Final Environmental Impact Report/
Final Environmental Impact Statement

Volume II: Responses to Comments

Bay Area
Rapid Transit District

BART-SAN FRANCISCO INTERNATIONAL AIRPORT EXTENSION

Area within 0.3 Miles Walking Distance
of a BART Entrance

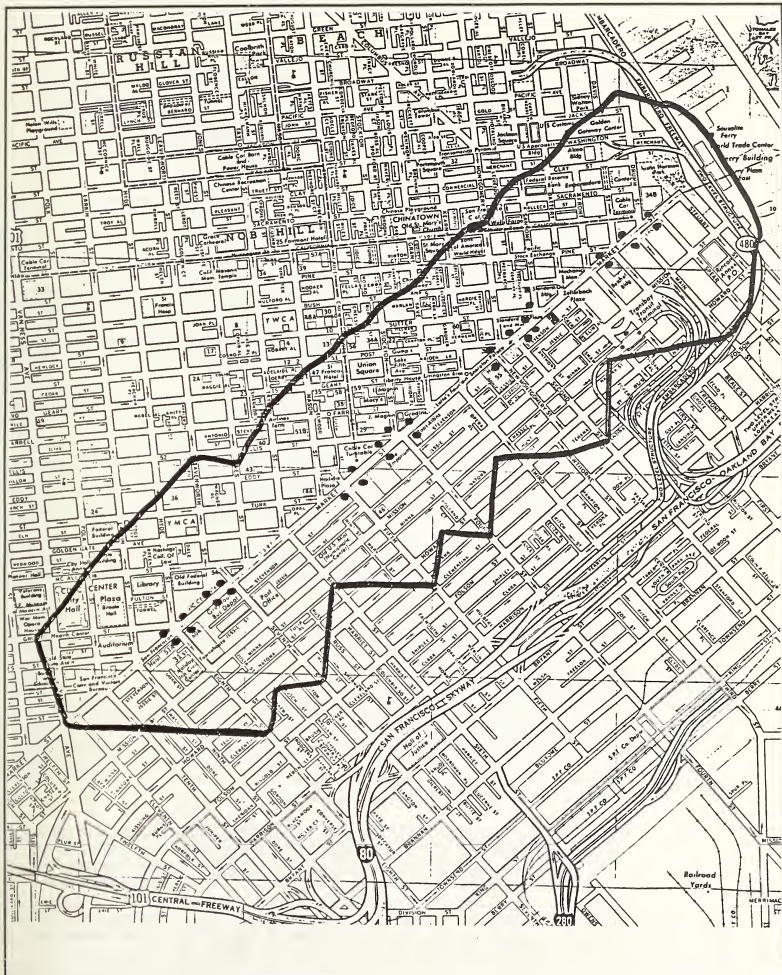
Connectivity. Figure 13.4-1 shows the area that can be reached within a 0.3-mile (5 to 10 minutes) walking distance of the Transbay Terminal. A CalBART station at the Transbay Terminal is within a 0.3 miles walking distance of many more jobs in downtown San Francisco than would be a CalTrain Transbay Terminal Station. The CalBART Transbay Terminal Station does not provide walking access to the entire Financial District. By comparison, Figure 13.4-2 shows a 0.3-mile walking distance from the four BART stations on Market Street. The existing Embarcadero, Montgomery, Powell, and Civic Center BART stations are within a 0.3-mile-radius walking distance of an even greater number of jobs in San Francisco. The four BART stations on Market Street provide walking-distance access to the Financial District, the Embarcadero, Union Square, and the Civic Center. San Mateo residents working in the Civic Center, retail areas near Union Square, or most of the San Francisco financial district would have more convenient access via BART than they would have via CalBART extended to the Transbay terminal. This holds true for San Mateo residents employed in the East Bay, and East Bay residents who travel to San Mateo County to work.
